#### **Addendum 128 – UN Regulation No. 129**

#### **Revision 1 - Amendment 8**

#### **Uniform provisions concerning the approval of Enhanced Child Restraint Systems used on board of motor vehicles (ECRS)**

Figure 2  
**ECRS Measurement Device - Side and Front View of the measuring device**

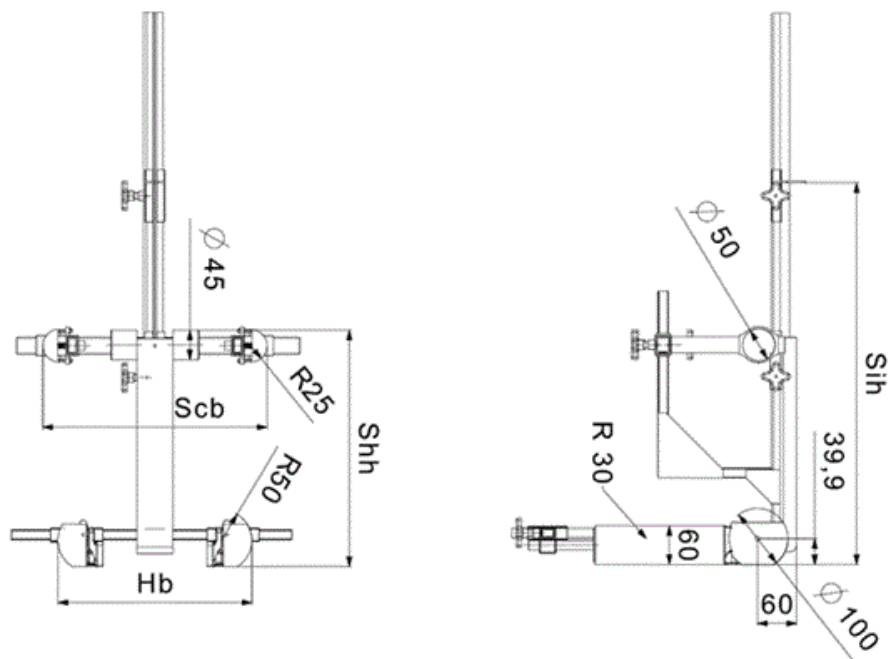
Annex 18., amend to read:

For integral or non-integral ECRS the device shown in Annex 18, Figure 2 shall be used.

The mass of the devices described in Figure 2 and Figure 3 shall be 10 kg +/- 1 kg.

All measurements shall be taken with the device base in contact with the seat pan of the ECRS and the device backrest in contact with the backrest of the ECRS. All lateral dimensions shall be measured under a contact force of 50 N with the devices described in Figure 2 and Figure 3 of this annex.

Figure 3  
**Side and Front View of the measuring device for measurements applicable to Enhanced Child Restraint Systems that feature an impact shield**

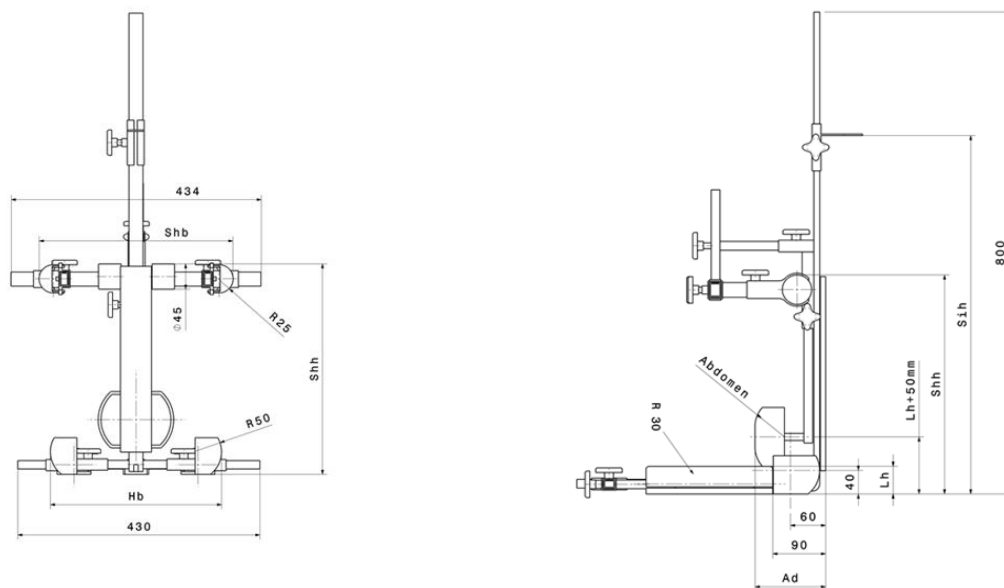
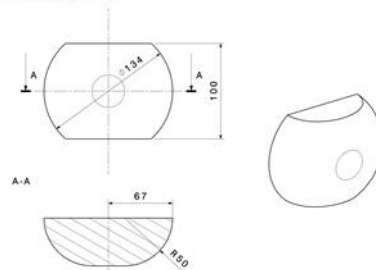
For ECRS with an impact shield the device shown in Annex 18, Figure 3 shall be used.
